GRADING & EROSION CONTROL PLAN

FOR
PRAIRIE RIDGE SUBDIVISION (BROWN ROAD)
 SOUTHEAST QUARTER OF SECTION 12, TOWNSHIP 11 SOUTH, RANGE 66 WEST OF THE 6th PRINCIPAL MERIDIAN,
 EL PASO COUNTY, COLORADO

GRADING & EROSION
CONTROL PLAN
PLAN & DETAILS

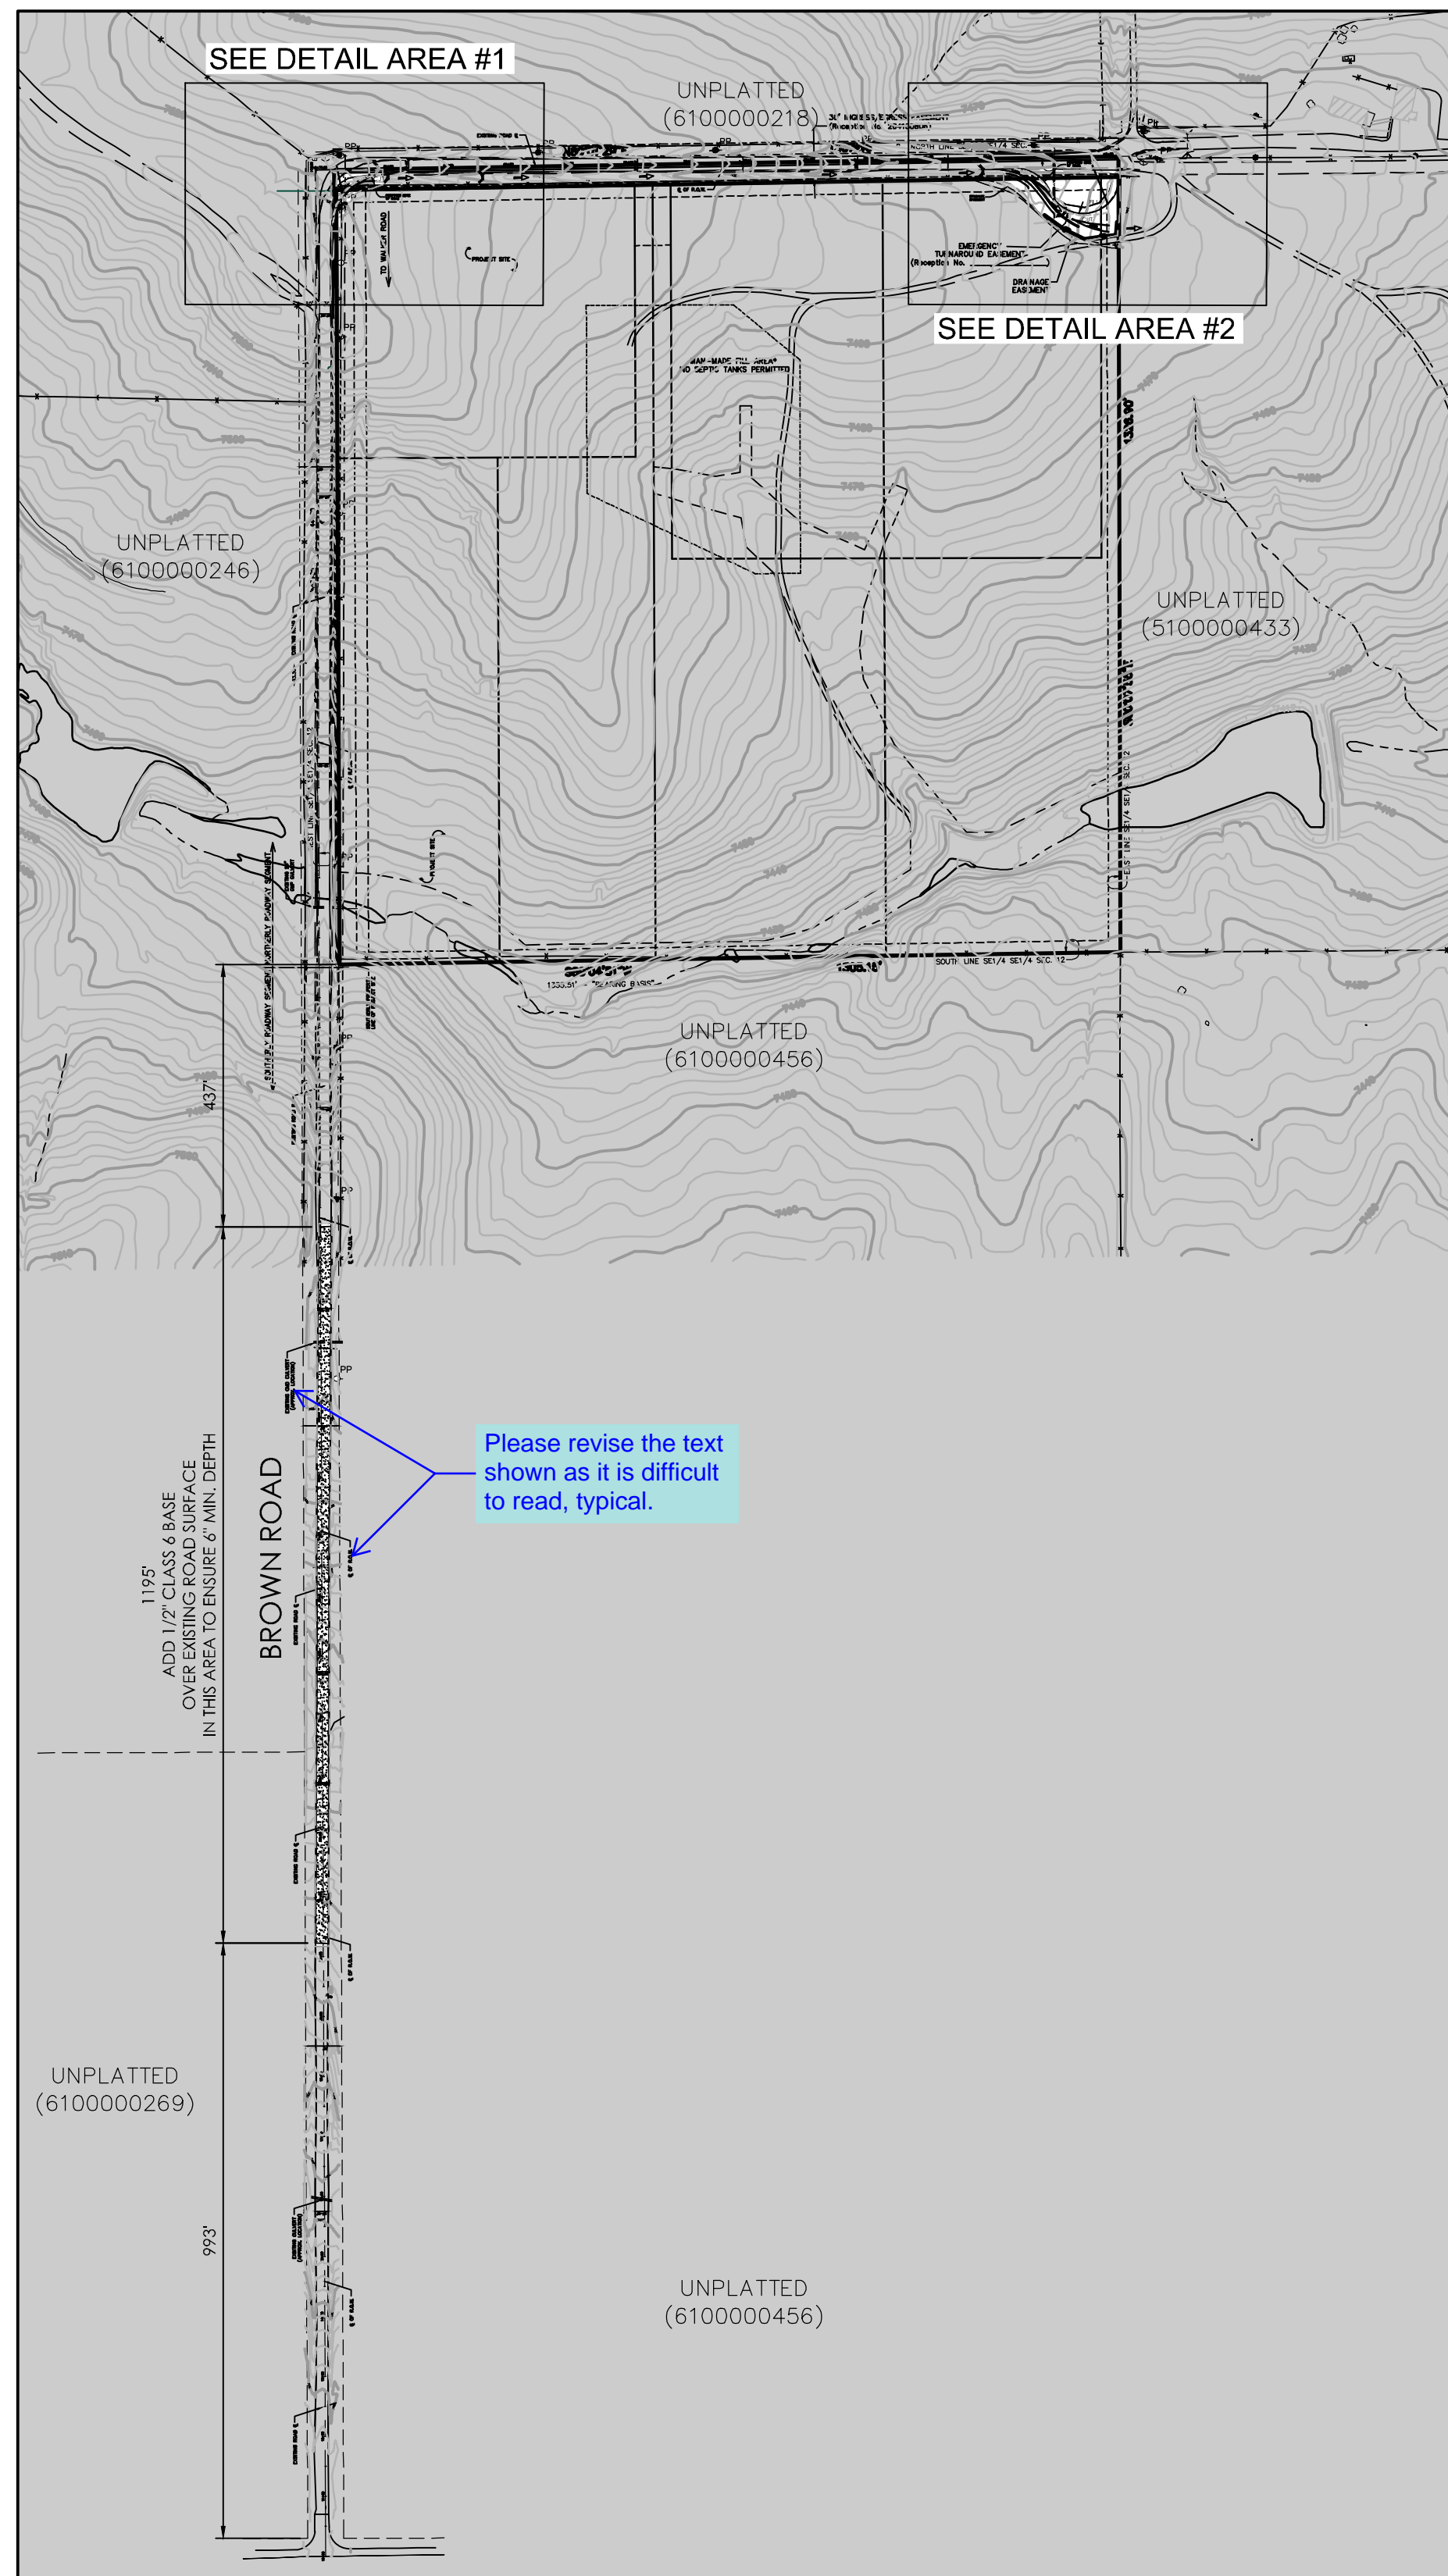
Please coordinate with the engineer that provided the Road Conditions report to ensure that all recommendations to be installed by the owner are shown on the plan. For instance riprap erosion protection at the outfall of the borrow ditch around the cul-de-sac is listed as an improvement to be installed as well as erosion control fabric along Brown Road in any disturbed areas yet these are not shown on the plan.

ROCK CHECK DETAIL (PERMANENT)

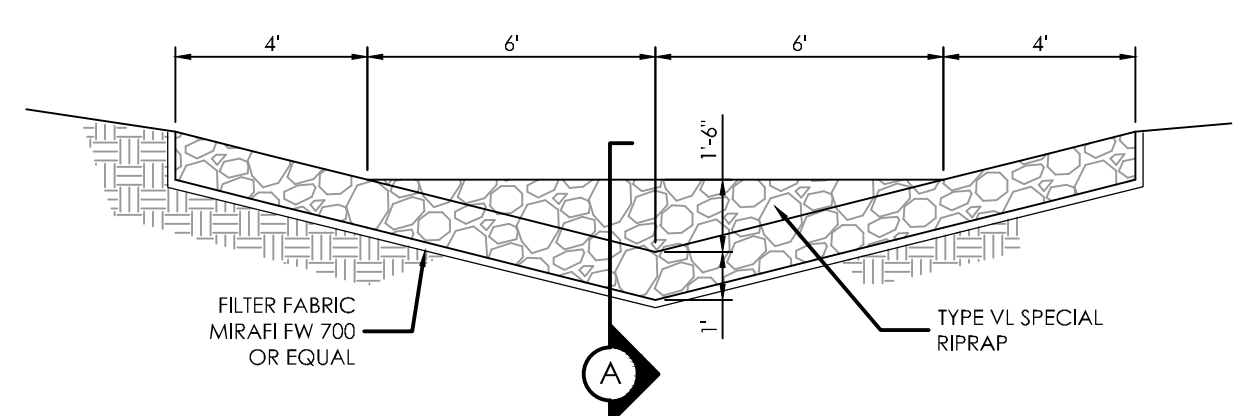
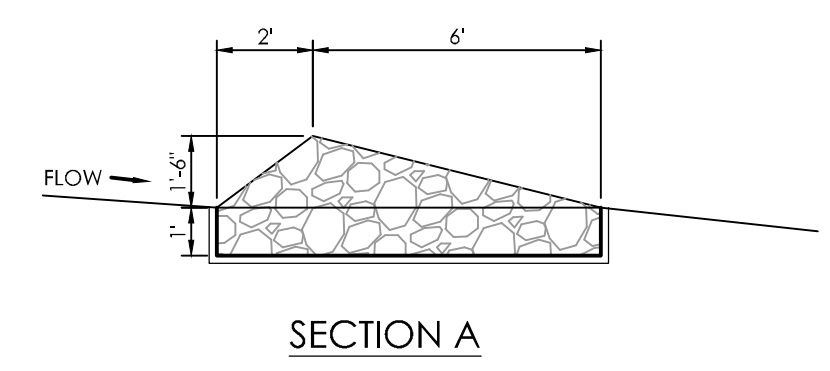
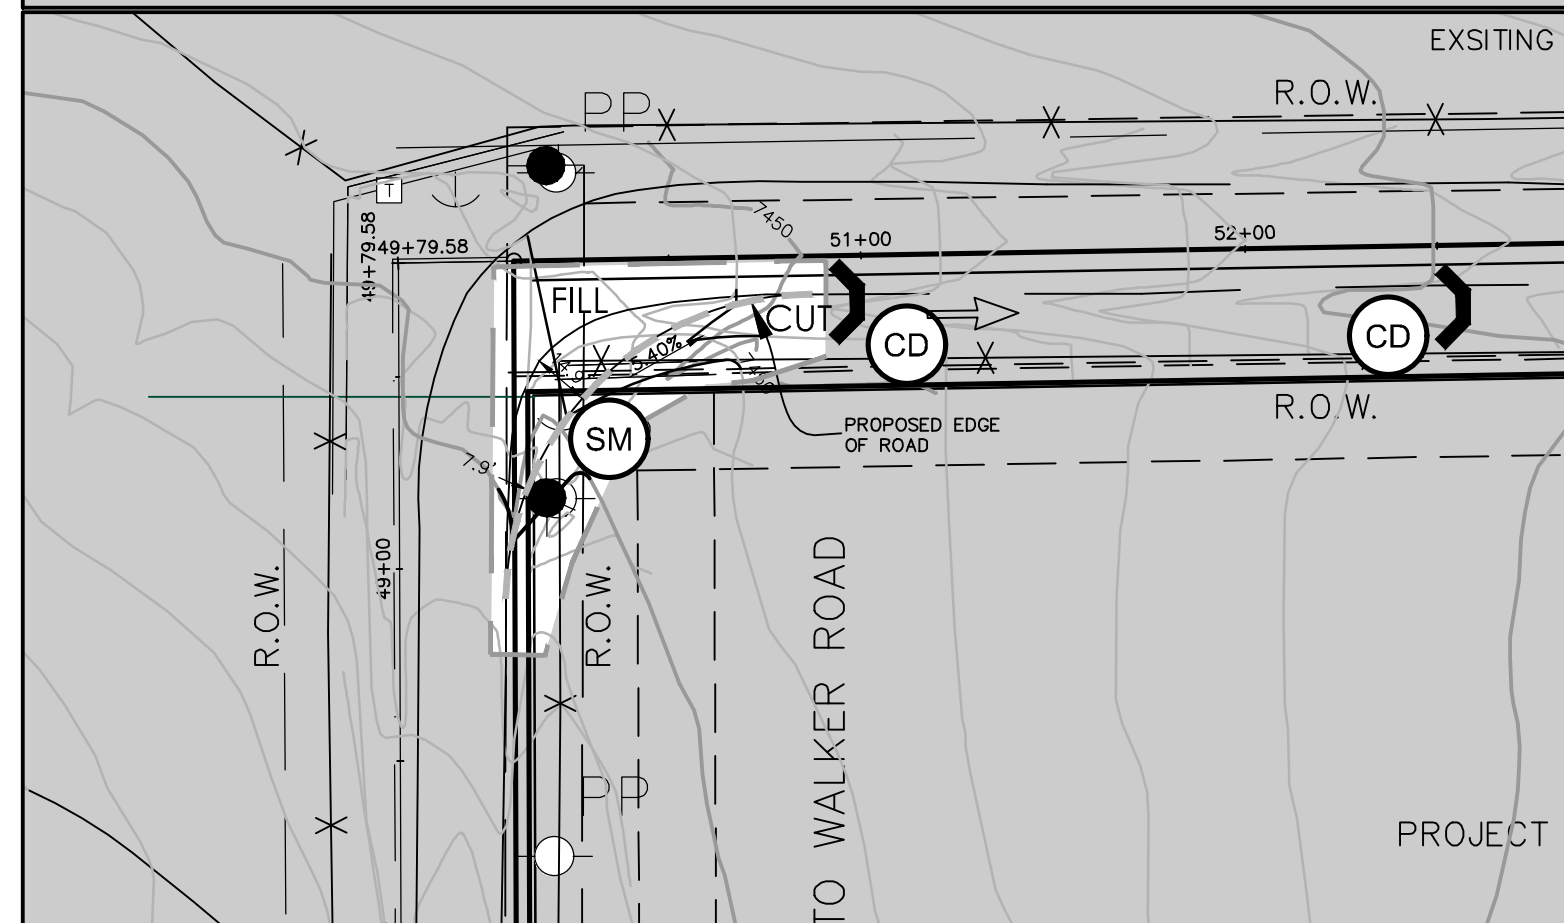
Per the detail provided and the recommendations of the road conditions report, rock check dams should be provided (RC) and listed on the plans instead of check dams (CD).

DETAILED AREA #2 1"=50'

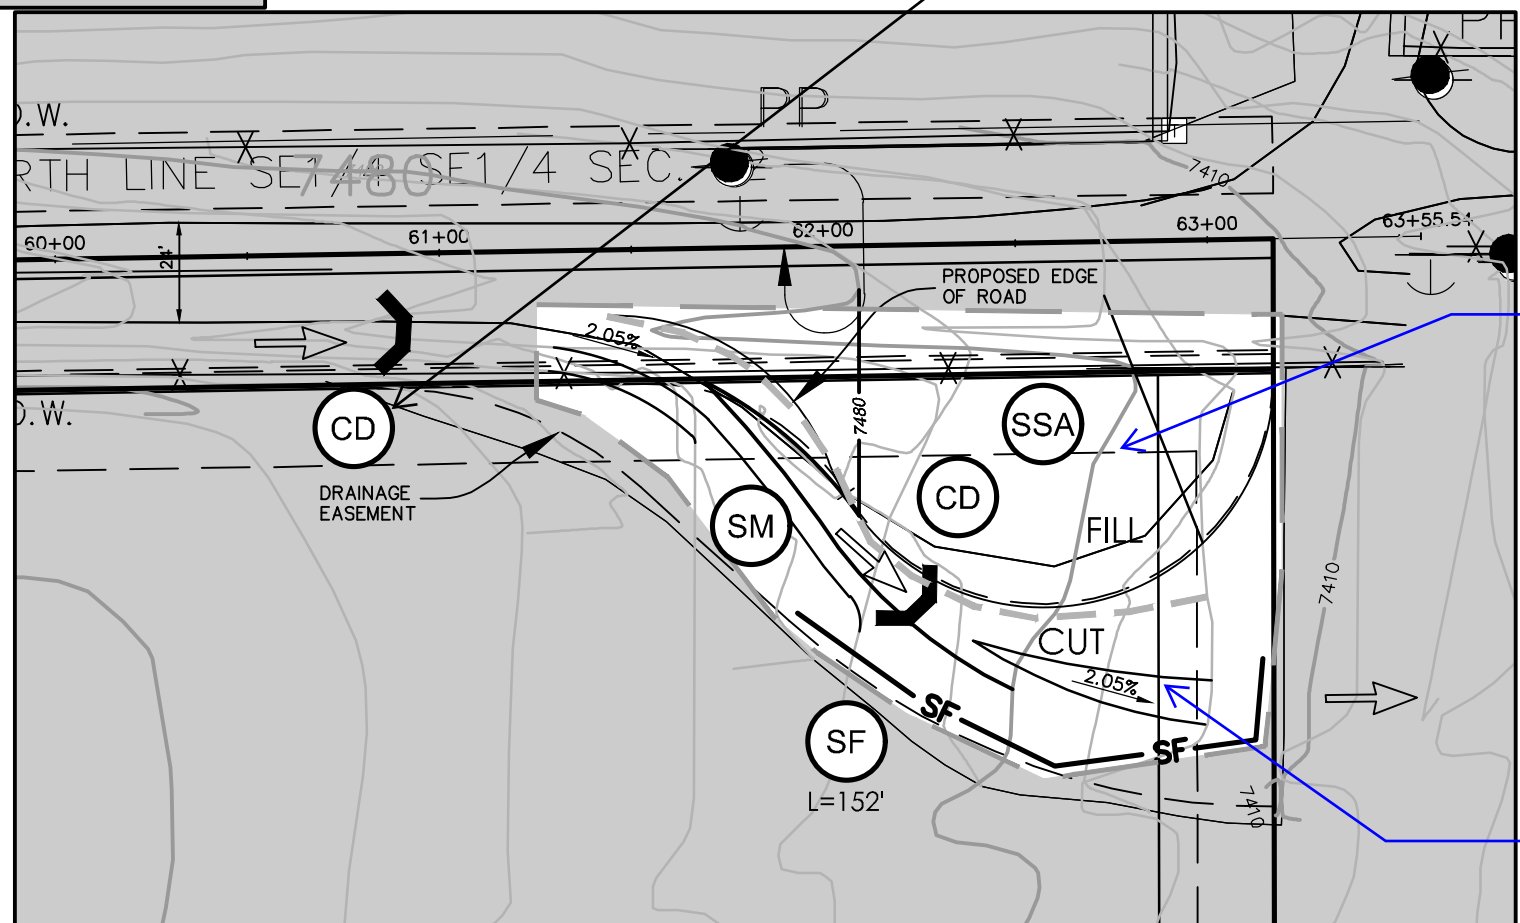
Please also identify that additional road base will be provided to provide a consistent 6" minimum thickness at the cul-de-sac, as indicated in the road conditions report (page 11 of 16)
